November 5, 2024

Project No. 294-22

ADDENDUM NO. 4

West Branch Rose City Area Schools
2022 Bond Issue – Bid Package No. 6 OHHS Well Upgrades
West Branch, Michigan

Revised Drawing Sheet EP dated October 31, 2024
Wellhouse Plumbing Piping Schematic

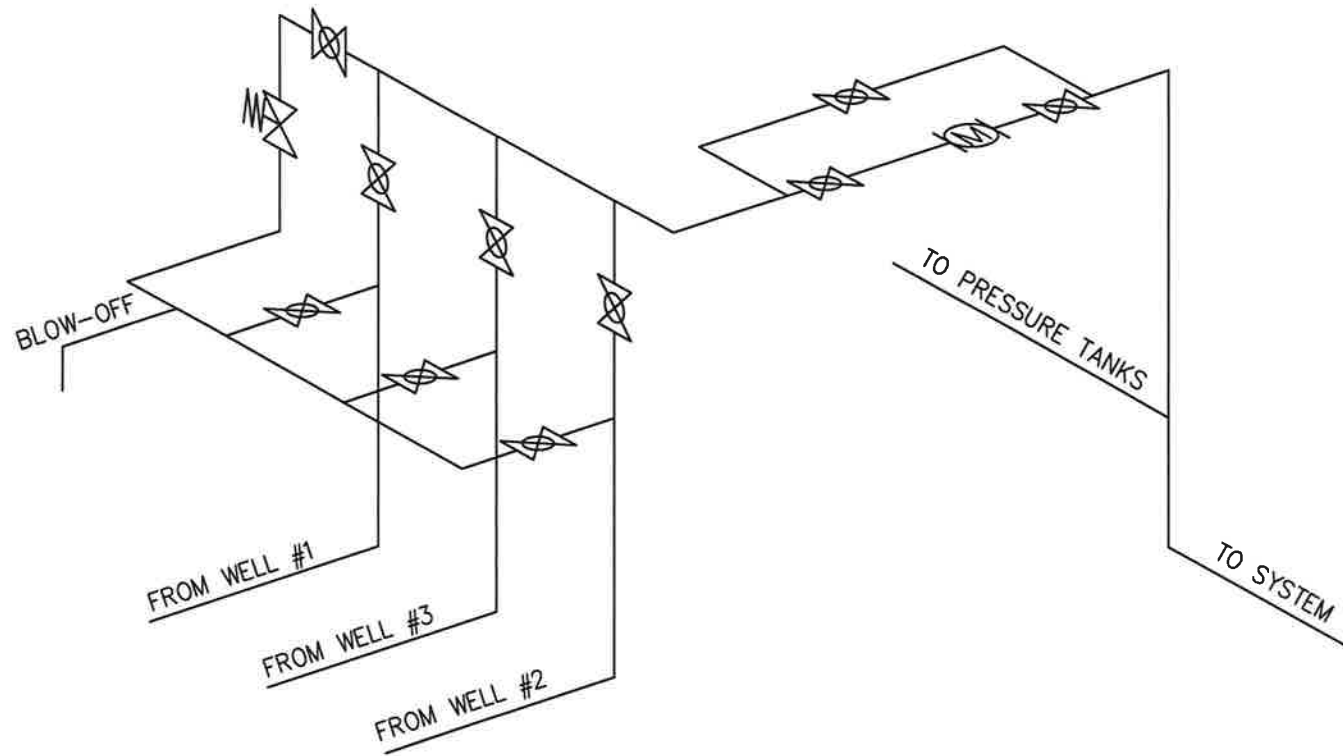
- Item No. 4 Refer to Bidding Drawing C3 dated September 26, 2024 and to the Wellhouse Plumbing Piping Schematic issued with this Addendum. The Wellhouse Plumbing Piping Schematic is issued to clarify the plumbing piping layout within the Wellhouse.

- Item No. 7 Refer to Revised Drawing EP dated October 31, 2024 issued with this Addendum: Load Reactor/Filters are not required and have been deleted from the scope of work.
